# UNITED STATES PATENT AND TRADEMARK OFFICE

APPLICATION NO.	FILING DATE	FIRST NAMED INVENTOR	ATTORNEY DOCKET NO.	CONFIRMATION NO.
10/781,775	02/20/2004	Chad G. Harris	S63.2B-13993-US01	3745

<b>Office Action Summary</b>	<b>Application No.</b> 10/781,775	<b>Applicant(s)</b> HARRIS ET AL.	
	<b>Examiner</b> QUYNH-NHU H. VU	<b>Art Unit</b> 3763

## **DETAILED ACTION**

**FIG. 2**

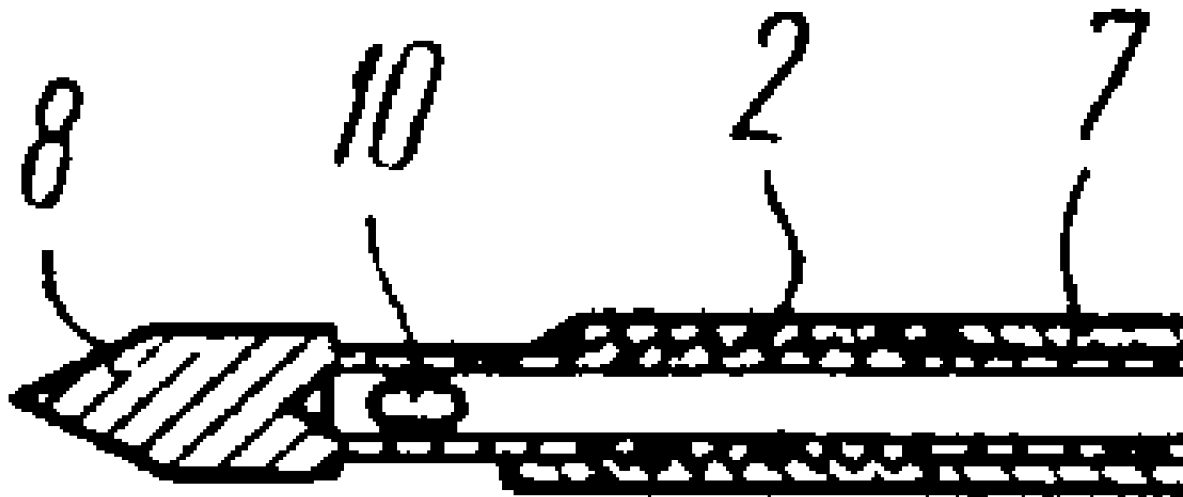
As best as understood, Pshenichny discloses a device comprising: a first elongated shaft 1 having a distal end and a proximal end and a first lumen extending there between; a needle 7 with a proximal end and a distal end and a needle lumen extending there between, the needle disposed within the first lumen of the first elongated shaft and extending from a proximal end of the catheter to a distal end of the catheter; a stop collar is a portion formed of a second set of male thread 2 corporate with a first set male thread of inside tube/needle 7 (Figs. 1-2 or see Fig. 2 below is enlarged); wherein rotation of the needle within the first elongated shaft can be caused longitudinal movement of the stop collar relative to the needle within the first elongated shaft because the threading motion step of two thread surface engaged with each other, the positioning of the stop collar/female thread section located within the first elongated shaft controlling a variable extent to which the needle may be extended beyond the distal end of the first elongated shaft; a means/restrictor 12, 13 for preventing rotation of the stop collar
